V2500-A1/A5 NACELLE SERVICE BULLETIN

This document transmits Revision 2 to Service Bulletin NV2500-26-0005 and Revision 2 to the Supplement

V2500-NAC-26-0005

NACELLE - FIRE PROTECTION - FIRE DETECTOR ASSEMBLY - REPLACEMENT OF

Installation of Accessory Zone Fire Detector
Figure 1

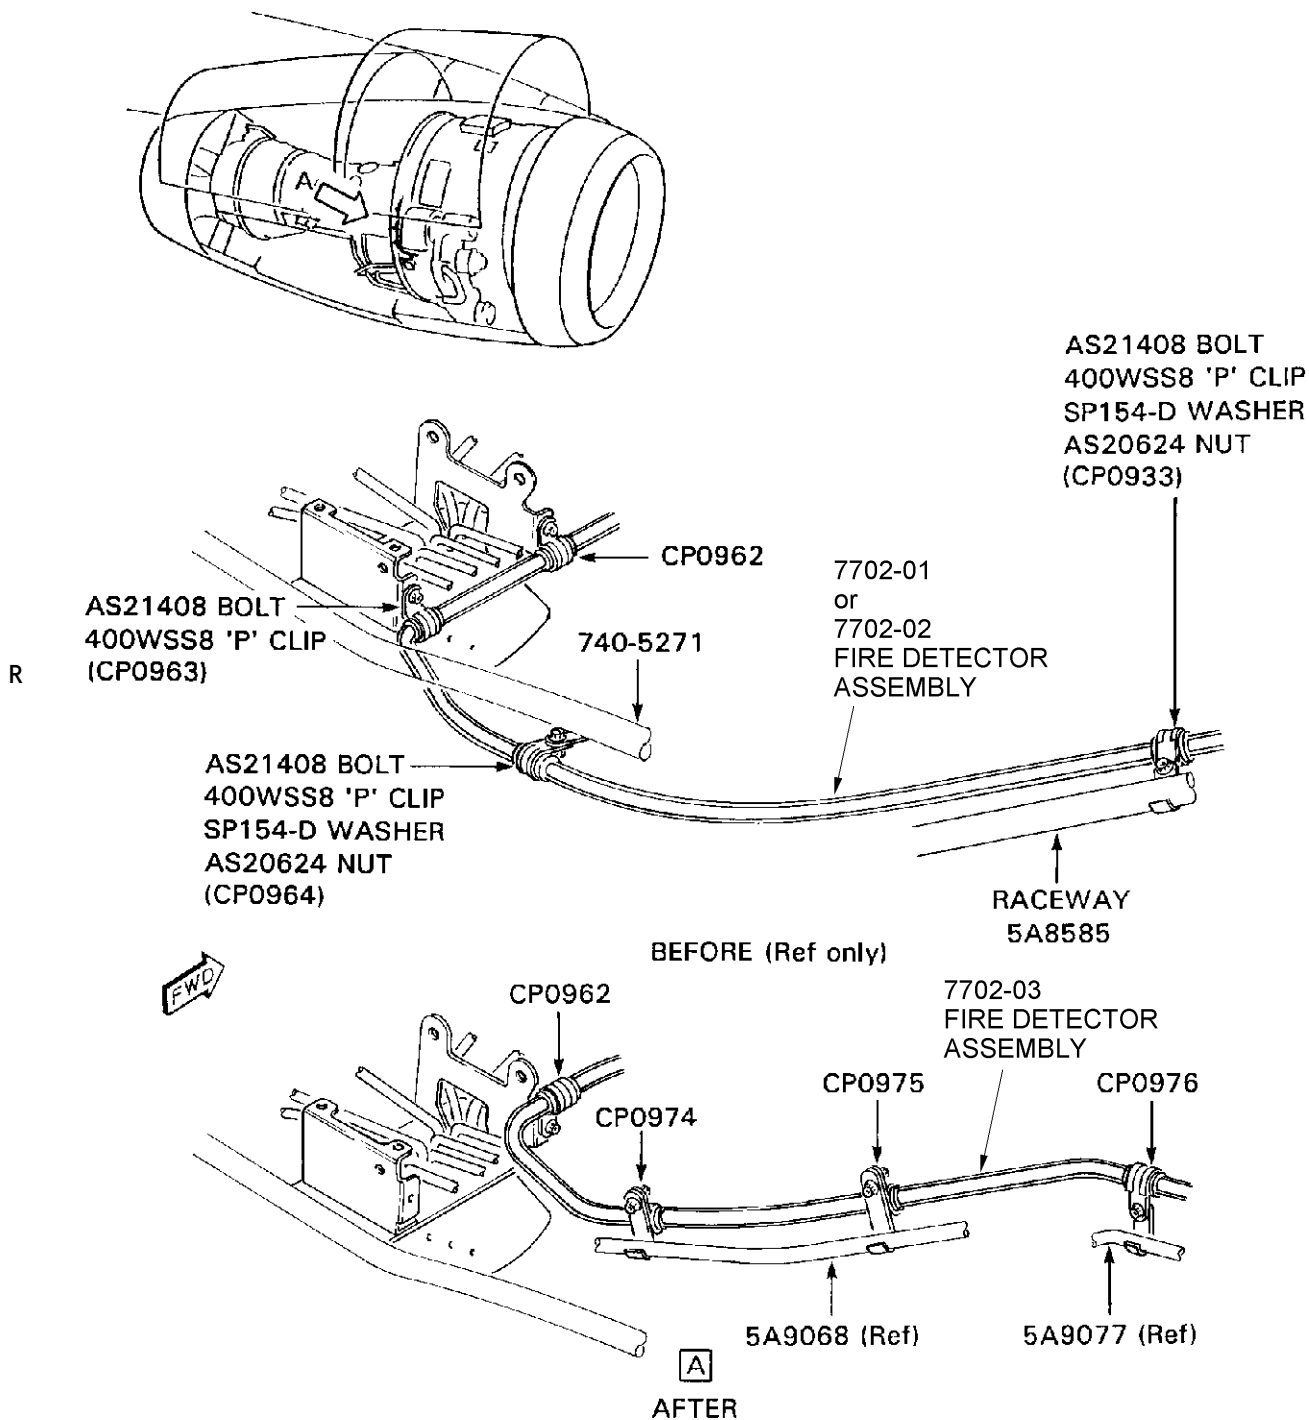
Existing firewire configuration impedes removal of the IDG. Additionally, the clearance between the firewire and Nos. 3 and 4 latches on the Fan Cowl Doors (FCD), was found to be inadequate on some units.

- (a) This Service Bulletin provides instructions to install a new firewire. The new firewire configuration introduces new clipping points CP0974, CP0975, CP0976 and rotates clipping point CP0962 thru 180 degrees . It deletes clipping points CP0963, CP0964, and CP0933.

- (1) Install the 7702-03 firewire with procedures in the V2500 Engine Manual, Chapter 72-00-60, Installation 04 (except for clipping points CP0962, CP0963, CP0964, and CP0933) and as follows:
 - (a) Assemble clipping point CP0962 in the orientation shown, with the AS21408 bolt, SP154D washer, and 400WSS8 P-clip. Hand tighten only at this stage. Refer to Figures 1 and 2.
 - (b) Assemble clipping point CP0974 as shown with an AS21408 bolt, SP154D washer, 400WSS8 P-clip, and AS20624 nut.
 - (c) Assemble clipping point CP0975 as shown with an AS21408 bolt, SP154D washer, 400WSS8 P-clip, and AS20624 nut.
 - (d) Assemble clipping point CP0976 as shown with an AS21408 bolt, SP154D washer, 400WSS8 P-clip, and AS20624 nut.
 - (e) Torque the nuts and bolts to 36-45 lbf-in (4-5 Nm).
 - (f) Make sure the firewire element is not bent or twisted.

Installation of Accessory Zone Fire Detector
Figure 2

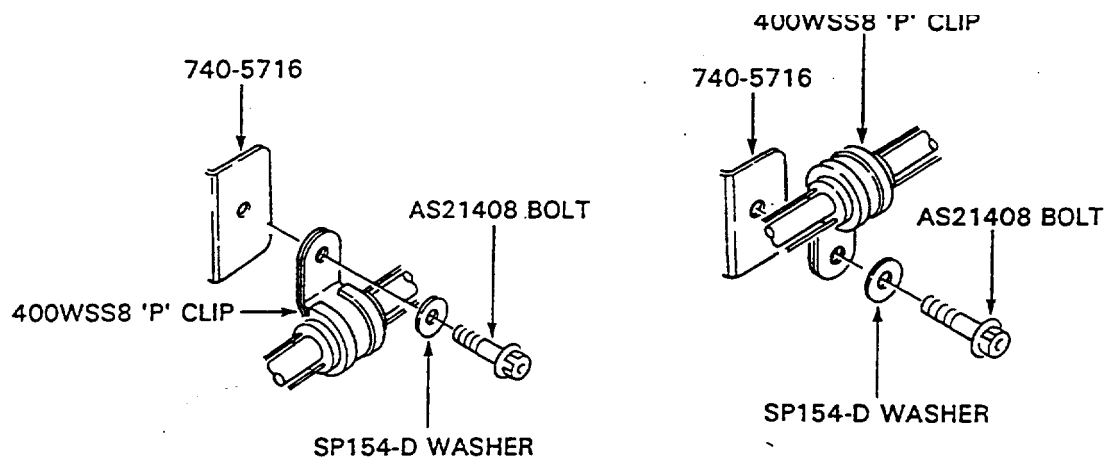
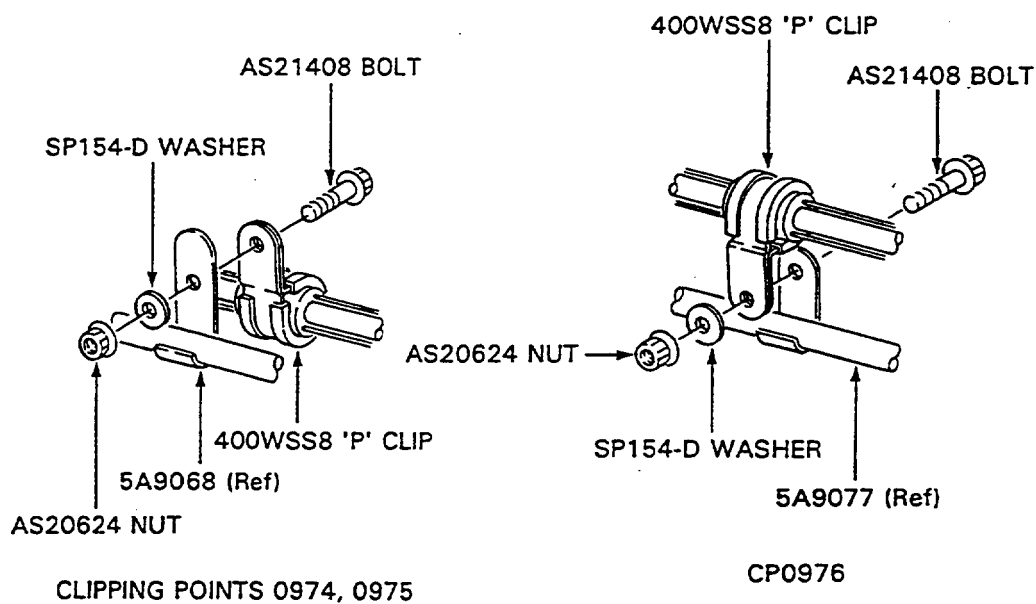
CP0962 BEFORE

CP0962 AFTER

CLIPPING POINTS 0974, 0975

CP0976
